# SERVICE BULLETIN

B-024A

## SAFETY RECALL CODE 0817 - REVISED SHOCK EYE

Figure 2. New Shock Absorber Assembly

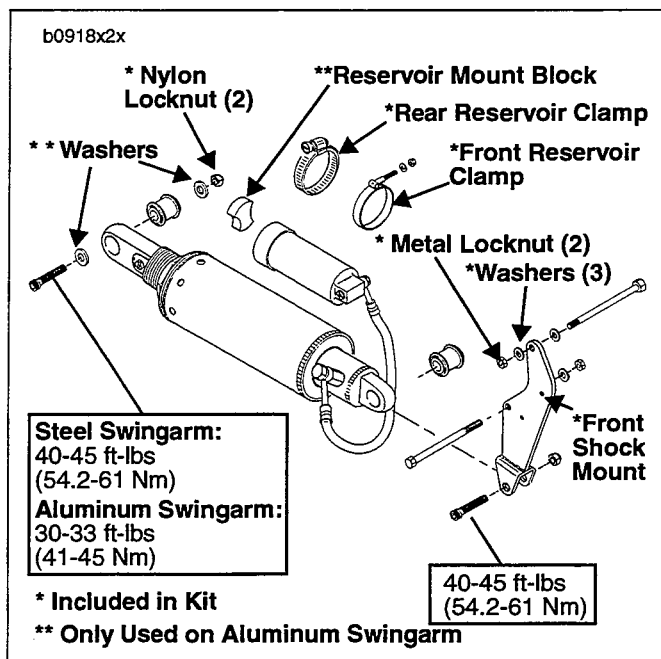
The new front shock mount **MUST** be used with the new shock absorber. The new shock is 1.77 in. (45 mm) shorter than the previous shocks and requires the new front mount to align and install properly.

1. See Figure 2. Install **new** front shock mount to crankcase with two **new** front shock mount bolts, washers, star washer (on 1997 M2, S3/S3T models only) and metal locknuts. Tighten bolts to 30-33 ft-lbs (41-45 Nm). **NOTE:** Top bolt goes in from the left side, bottom bolt goes in from right side. Bottom bolt does not use washer under bolt head. Star washer (only used on 1997 M2, S3/S3T models) goes on bottom bolt under the washer on the nut side. If exhaust was loosened during front shock mount removal, replace exhaust gaskets and reinstall exhaust. See appropriate Service Manual, Section 2 for instructions.

4. See Figure 2. Position **new** shock absorber from kit in mounting position.
5. Loosely install bolt, washers (aluminum swingarms only) and **new** locknut through rear shock eye and swing arm.
6. Loosely install bolt and **new** locknut through front shock eye and front shock mount.
7. **On 1996-1998 vehicles only:** Loosen header tie bar from collector.
8. Position front clamp over reservoir. Loosely install **new** front reservoir clamp to front shock mount (and install **new** header tie bar spacer between front shock mount and header tie bar on 1996-98 vehicles only) with **new** washer and **new** nylon locknut.
9. See Figure 3. Loosely install **new** rear clamp around reservoir and oil feed line.
10. **All Models:** Install **new** reservoir mount block between oil pump fitting and remote reservoir.

**Figure 4. Measuring Preload**

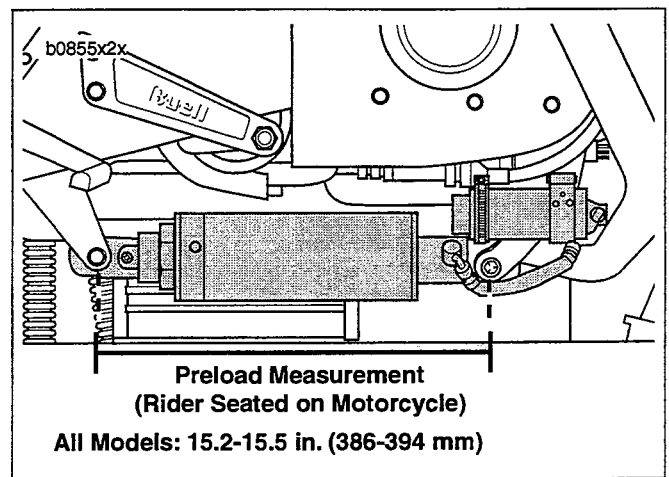
1. See Figure 4. Check and adjust rear shock preload.
  - a. With rider seated on motorcycle, the preload is determined by measuring the distance between the centers of the front and rear shock eye and adjusting until the measurement is within specification.
  - b. See below for optimum preload measurements:
    - **All Models:** 15.2-15.5 in. (386-394 mm)

**Figure 5. Preload and Compression Adjustments**

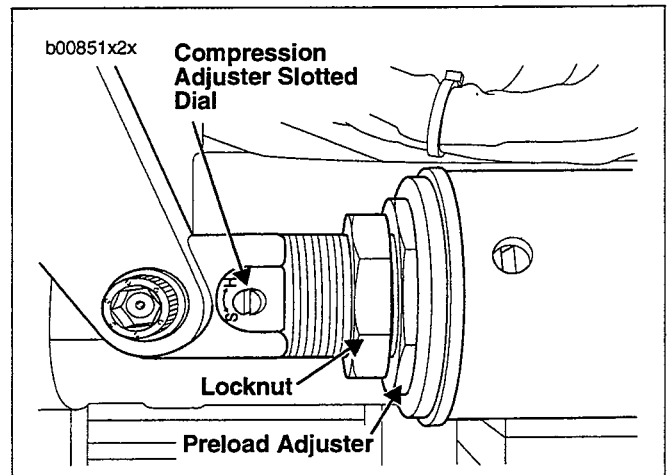
3. See Figure 5. Set compression damping using the slotted dial on the shaft at the end of the shock. New factory setting is as listed below:
    - **S1/S1W/M2 Models:** full damping minus 2.25 turns.

**Figure 6. Rebound Adjustment**

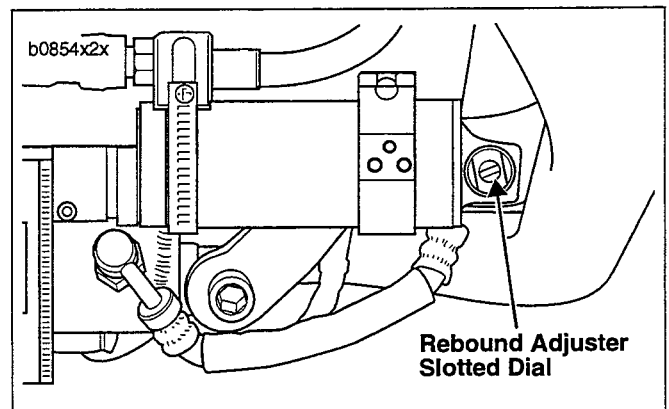
- **S2/S2T Models:** full damping minus 2.5 turns.
    - **S3/S3T Models:** full damping minus 2.5 turns.
  4. See Figure 6. Set rebound damping using the slotted dial on the remote reservoir at the front of the shock. New factory setting is as listed below:

- **S1/S1W/M2 Models:** full damping minus 1.5 turn.
    - **S2/S2T Models:** full damping minus 1 turn.
    - **S3/S3T Models:** full damping minus 1 turn.
